**APPENDIX A AMENDMENT**  
**T198 LINE – STRUCTURE 29-30**  
**SOUTH BRANCH OF ASHUELOT RIVER AND STATE ACQUIRED**  
**RAILROAD PROPERTY**  
**TROY, NH**

1. The design and proposed construction of this crossing is shown on the attached PSNH Transmission Drawing entitled “LINE T198 (115 KV) CROSSING BETWEEN STR. 29 & 30, SOUTH BRANCH ASHUELOT RIVER, TROY, NEW HAMPSHIRE”.

THIS DRAWING REPLACES THE PREVIOUS DRAWING DATED 7/2008 AND CONTAINS UPDATED CABLE SAGS & CLEARANCES.

<b>Public Service of New Hampshire</b>	<b>TRANSMISSION BUSINESS</b>
	<b>LINE T198 (115kV) CROSSING BETWEEN STR. 29 &amp; 30 SOUTH BRANCH ASHUELOT RIVER CROSSING TROY, NEW HAMPSHIRE</b>	
DRAWN RRR ENGINEER AM CHECKED RPL APPROVED DMB	SCALE AS SHOWN	DATE 8/13
EXHIBIT A2 & A3 AMENDMENT		DRAWING NO.

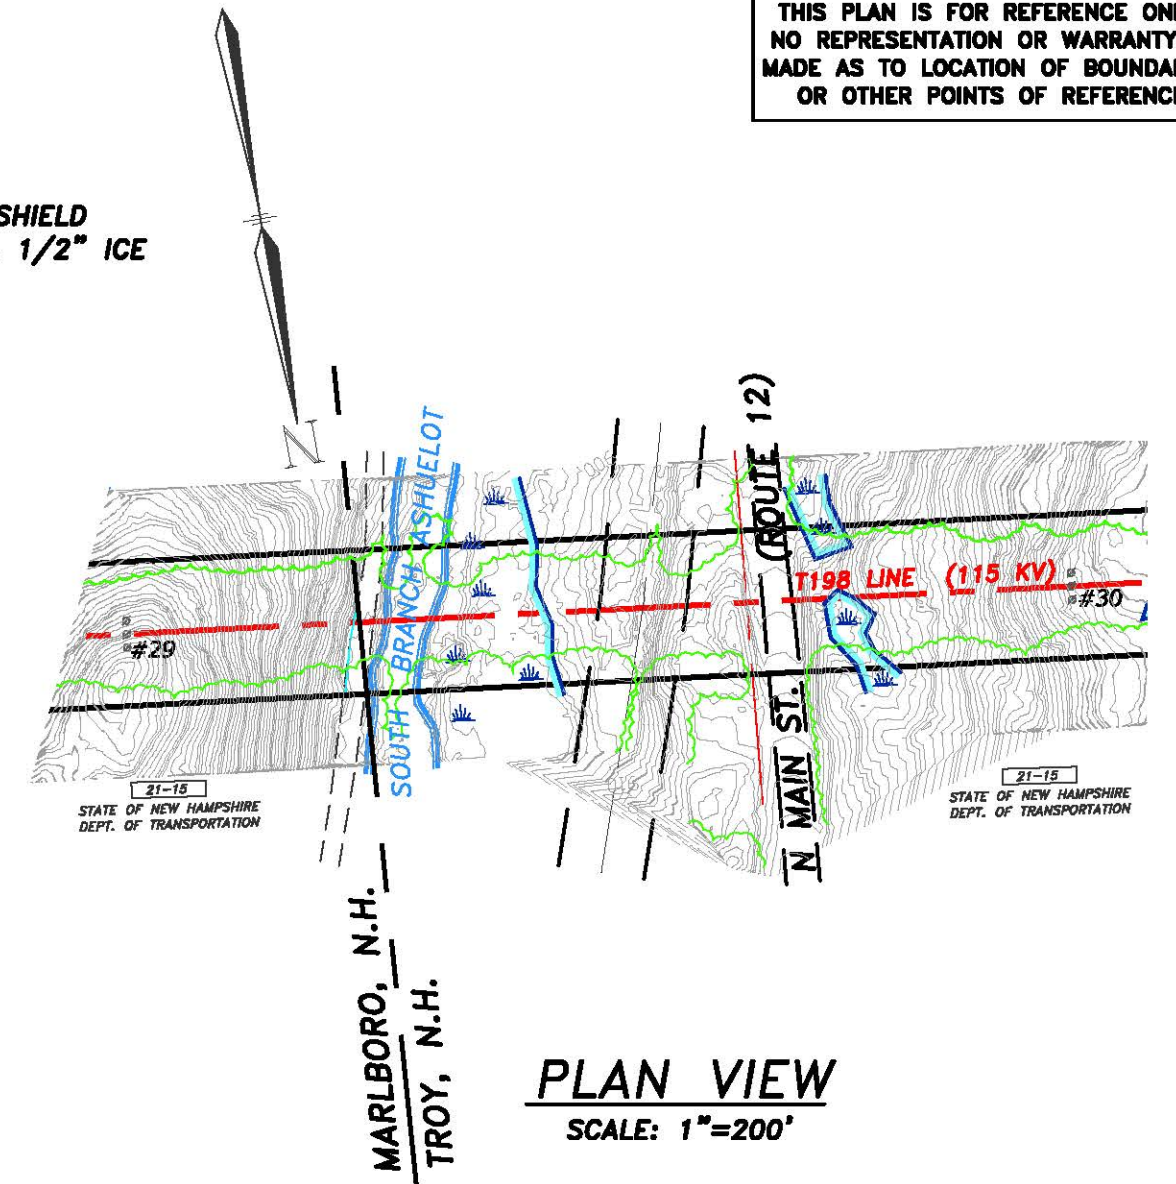
2. Currently, Line T198 crosses the Ashuelot River on a 60’ type DA structure (West) and a 50’ type DA structure (East) with a span of 985.25 feet. Detailed drawings of these structures have been provided with his amendment. Minimum distances to ground for truck traffic on Route 12 of 15.5 feet for the ADSS and 20.1 feet for the 115kV open supply per the NESC have been met as 59.8 and 72.3 feet of clearance is provided respectively for the ADSS and conductor wires.

6. As stated in the NESC (Table 232-1, Note 18), the surface area shall be enclosed by its high water mark and clearances shall be based on the normal flood level. In this case, the final river elevation at this location during the normal flood is 880.8 feet. The current sags and clearances to the water surface are as follows:

- Conductors (phase wires) – The maximum sag for the conductor will occur under the maximum operating condition (285 deg F). This condition produces the greatest sag and therefore the minimum clearance to water surface and railroad track path. At the time of the original petition, the clearance to water surface exceeded the minimum requirement of 22.1 feet with a clearance of 112.3 feet under temporary emergency conditions. It also exceeded the minimum clearance requirement for a railroad track of 28.5 feet with a clearance of 85.9 feet under temporary emergency conditions. The clearance to the water surface of the conductor, under the maximum operating condition, after thermal uprate will be 109.1 feet. The clearance to the railroad track of the conductor, under the maximum operating condition, after thermal uprate will be 80.2 feet.

- ADSS cable – The maximum sag for the ADSS cable will occur under the weather case of 32 deg F; ½ inch radial ice; no wind and therefore produces the minimum clearance to the water surface. At the time of the original petition, the clearance to water surface exceeded the minimum requirement of 17.5 feet with a clearance of 98.7 feet. It also exceeded the minimum clearance requirement for a railroad track path of 23.5 feet with a clearance of 73.3 feet.

TRANSMISSION BUSINESS
	LINE T198 (115kV) CROSSING BETWEEN STR. 71 & 72 SOUTH BRANCH ASHUELOT RIVER CROSSING SWANZEY, NEW HAMPSHIRE
DRAWN RRR ENGINEER AM CHECKED RPL APPROVED DMB	SCALE AS SHOWN DATE 8/13 DRAWING NO. EXHIBIT B2 AMENDMENT

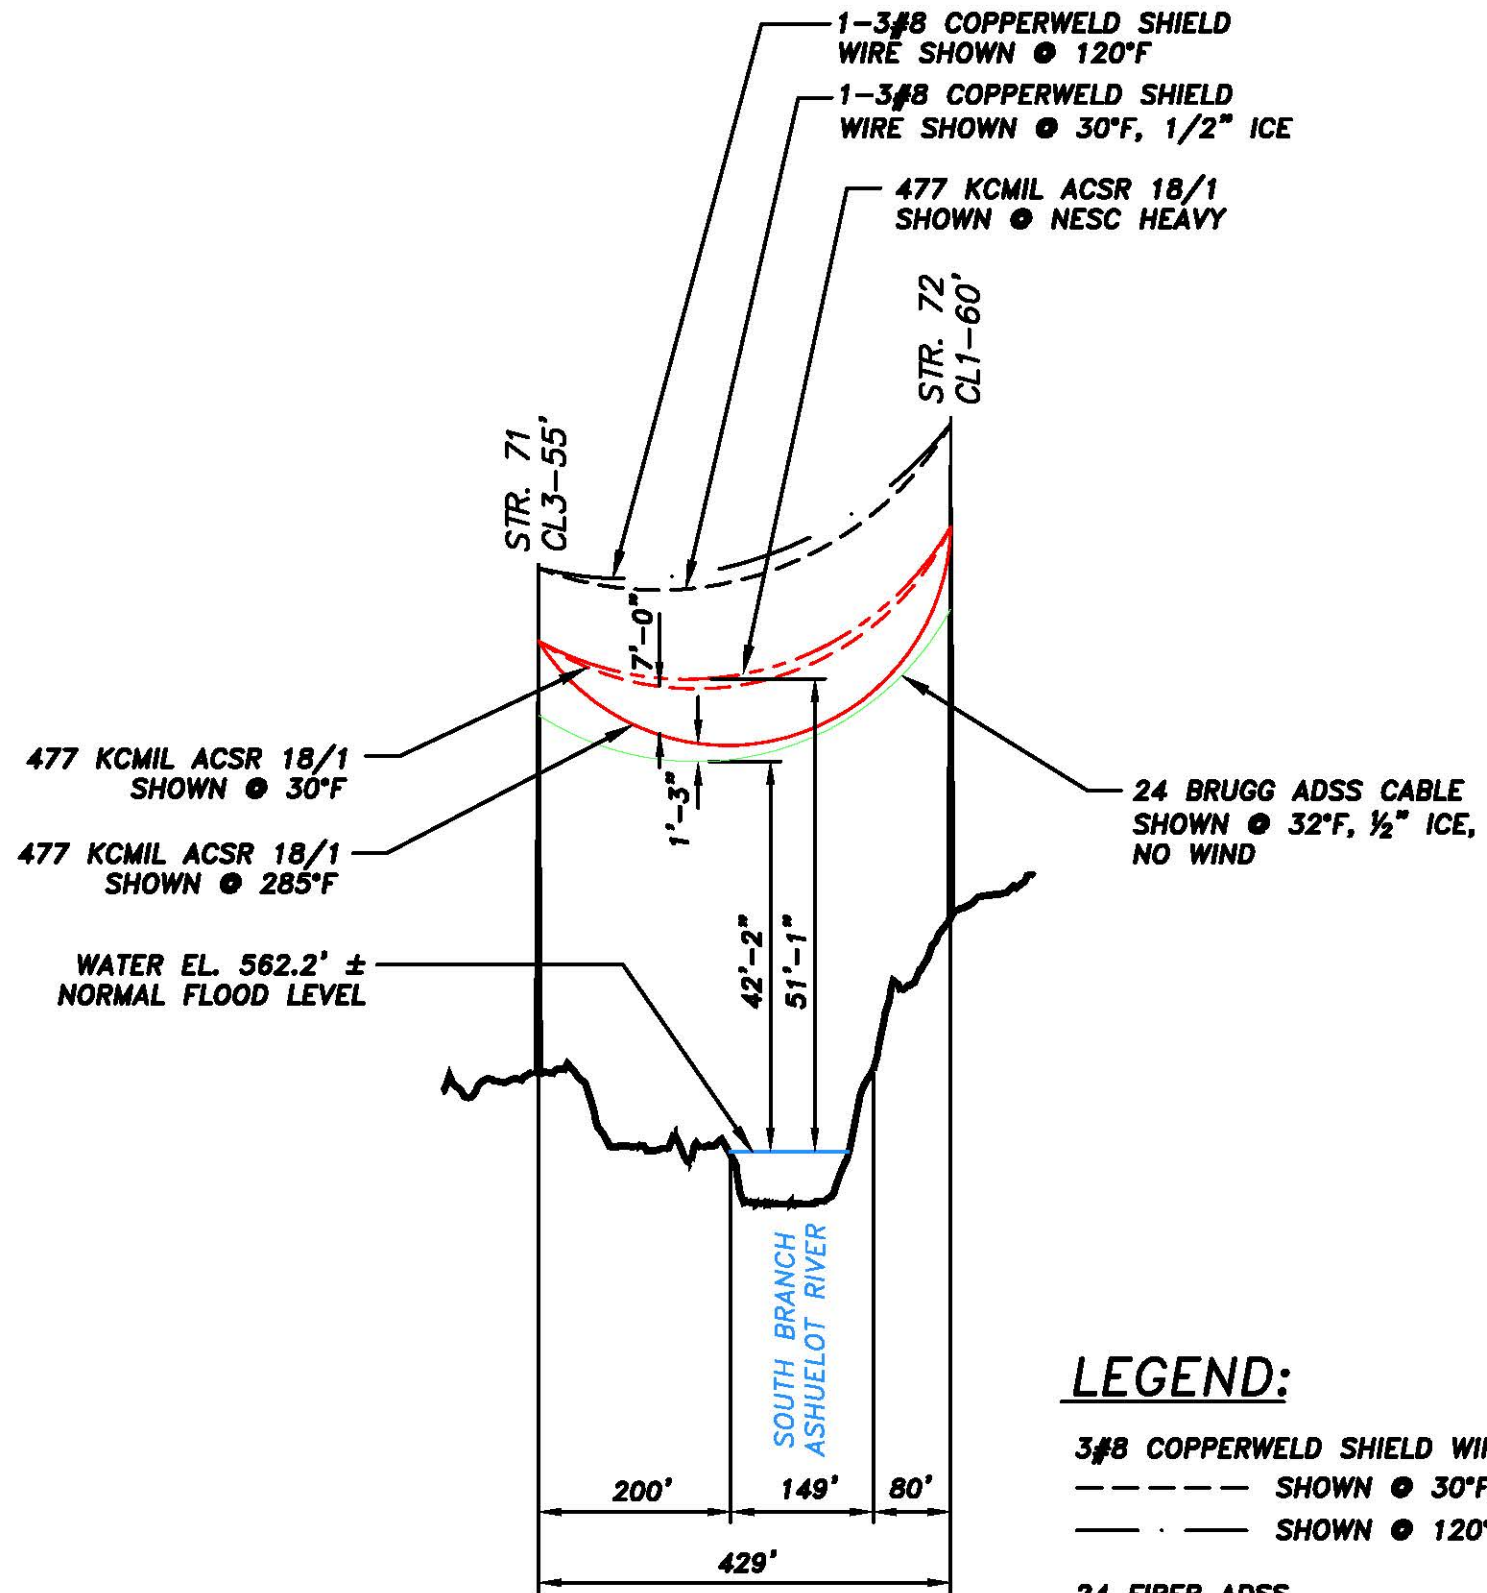
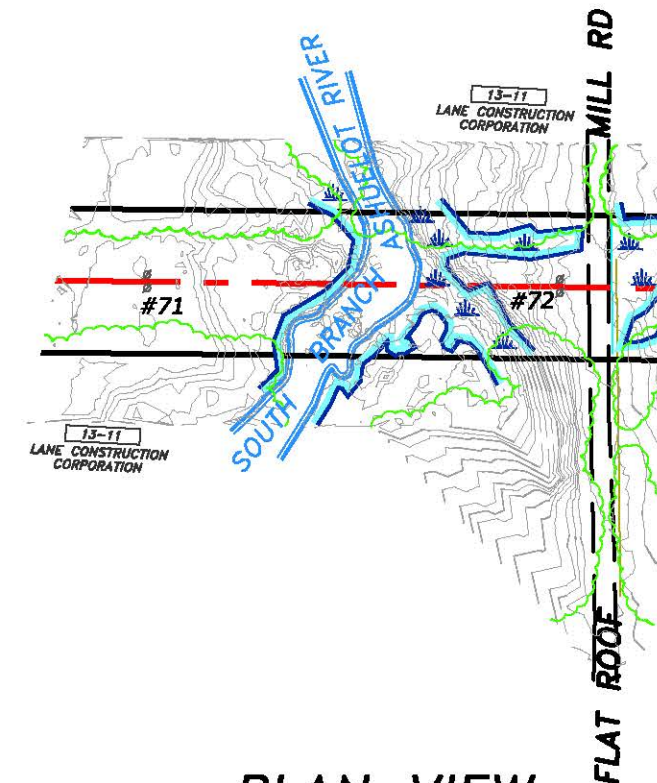
2. Currently, Line T198 crosses the South Branch Ashuelot River on a 60’ type D structure (West) and a 55’ type A structure (East) with a span of 429.42 feet. Detailed drawings of these structures have been provided with his amendment. Minimum distances to ground for truck traffic of 15.5 feet for the ADSS and 20.1 feet for the 115kV open supply per the NESC have been met as 32.2 and 36.0 feet of clearance is provided respectively for the ADSS and conductor wires.

6. As stated in the NESC (Table 232-1, Note 18), the surface area shall be enclosed by its high water mark and clearances hall be based on the normal flood level. In this case, the final river elevation at this location during the normal flood is 562.2 feet. The current sags and clearances to the water surface are as follows:

- Conductors (phase wires) – The maximum sag for the conductor will occur under the maximum operating condition (285 deg F). This condition produces the greatest sag and therefore the minimum clearance to water surface. At the time of the original petition, the clearance to water surface exceeded the minimum requirement of 22.1 feet with a clearance of 42.4 feet under temporary emergency conditions. The clearance to the water surface of the conductor, under the maximum operating condition, after thermal uprate will be 43.4 feet.

- ADSS cable – The maximum sag for the ADSS cable will occur under the weather case of 32 deg F; ½ inch radial ice; no wind and therefore produces the minimum clearance to the water surface. At the time of the original petition, the clearance to water surface exceeded the minimum requirement of 17.5 feet with a clearance of 42.2 feet

THIS DRAWING REPLACES THE PREVIOUS DRAWING DATED 7/2008 AND CONTAINS UPDATED CABLE SAGS & CLEARANCES.

TRANSMISSION BUSINESS
	LINE T198 (115kV) CROSSING BETWEEN STR. 97 & 98 SOUTH BRANCH ASHUELOT RIVER CROSSING SWANZEY, NEW HAMPSHIRE
DRAWN: RRR ENGINEER: AM CHECKED: RPL APPROVED: DMB	SCALE: AS SHOWN DATE: 8/13 DRAWING NO.: EXHIBIT C2 AMENDMENT

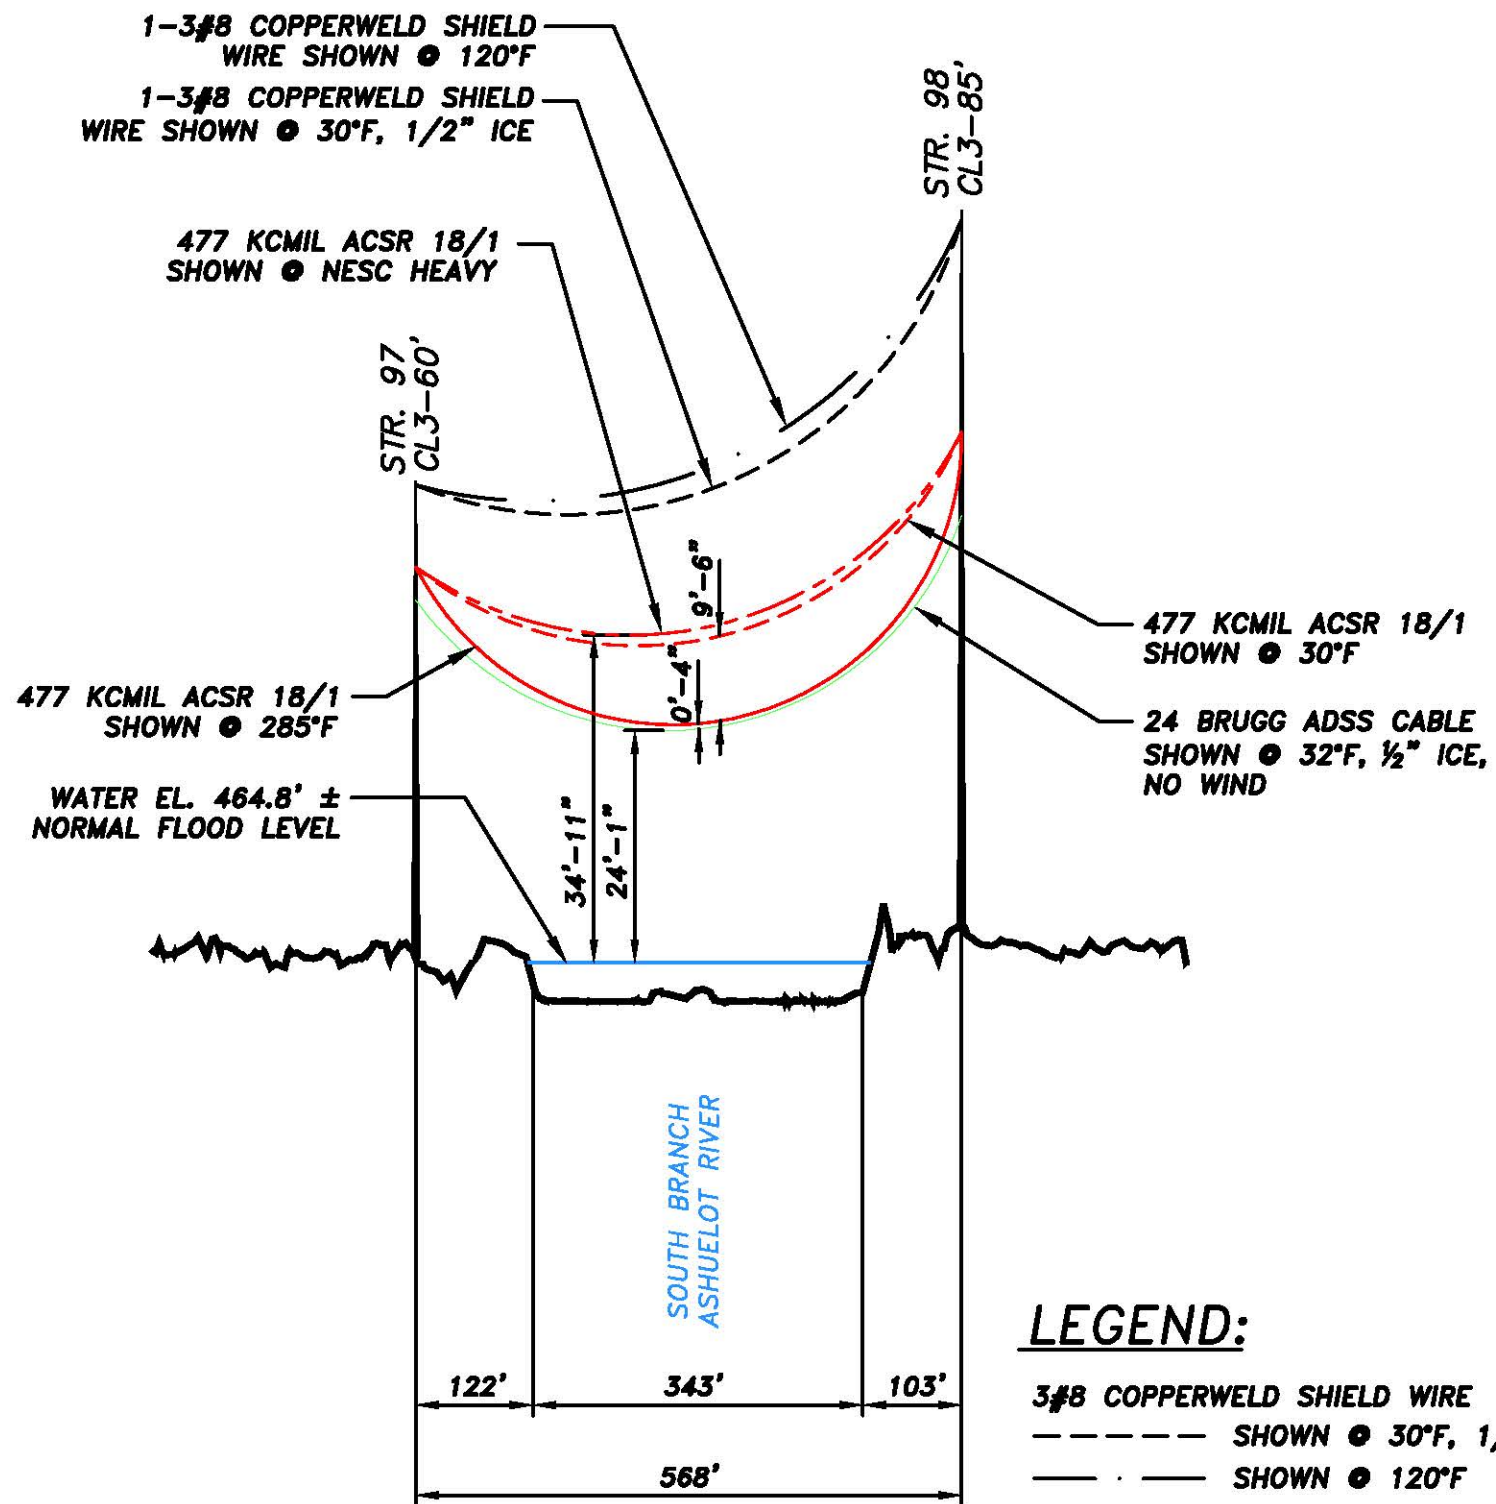
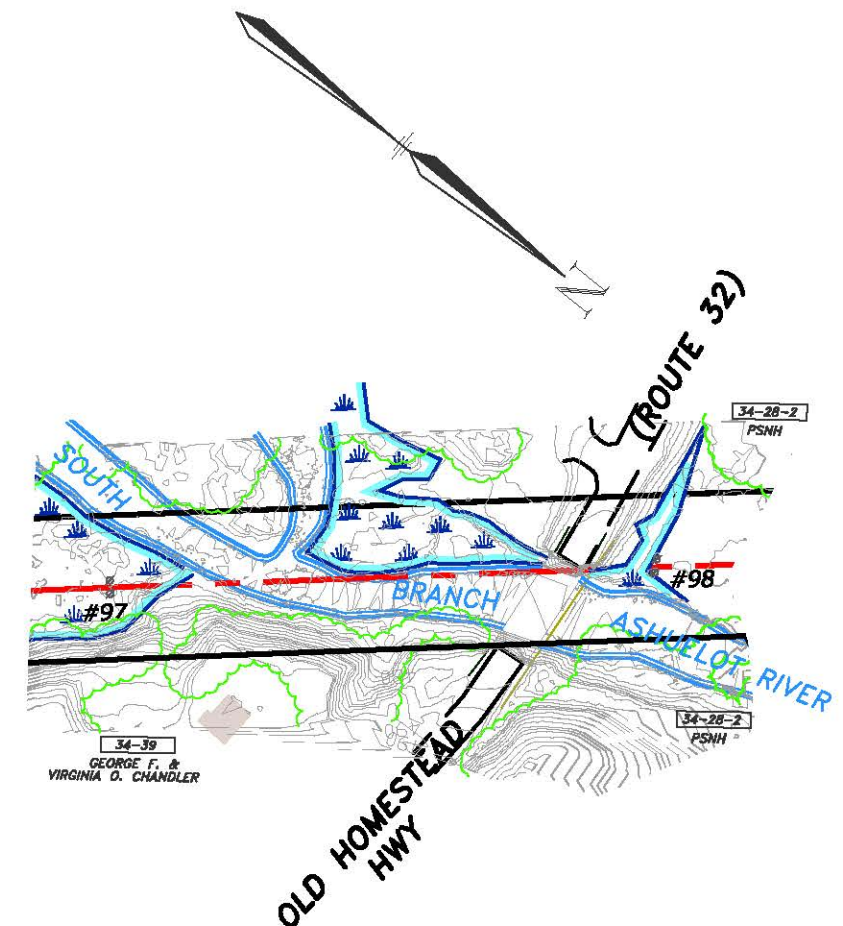
2. Currently, Line T198 crosses the South Branch Ashuelot River on an 85’ type RA structure (West) and a 60’ type A structure (East) with a span of 568.29 feet. Detailed drawings of these structures have been provided with his amendment. Minimum distances to ground for truck traffic on Route 32 of 15.5 feet for the ADSS and 20.1 feet for the 115kV open supply per the NESC have been met as 22.5 and 22.7 feet of clearance is provided respectively for the ADSS and conductor wires.

6. As stated in the NESC (Table 232-1, Note 18), the surface area shall be enclosed by its high water mark and clearances hall be based on the normal flood level. In this case, the final river elevation at this location during the normal flood is 464.8 feet. The current sags and clearances to the water surface are as follows:

- Conductors (phase wires) – The maximum sag for the conductor will occur under the maximum operating condition (285 deg F). This condition produces the greatest sag and therefore the minimum clearance to water surface. At the time of the original petition, the clearance to water surface exceeded the minimum requirement of 22.1 feet with a clearance of 30.0 feet under temporary emergency conditions. The clearance to the water surface of the conductor, under the maximum operating condition, after thermal uprate will be 24.4 feet.

- ADSS cable – The maximum sag for the ADSS cable will occur under the weather case of 32 deg F; ½ inch radial ice; no wind and therefore produces the minimum clearance to the water surface. At the time of the original petition, the clearance to water surface exceeded the minimum requirement of 17.5 feet with a clearance of 24.1 feet

THIS DRAWING REPLACES THE PREVIOUS DRAWING DATED 7/2008 AND CONTAINS UPDATED CABLE SAGS & CLEARANCES.
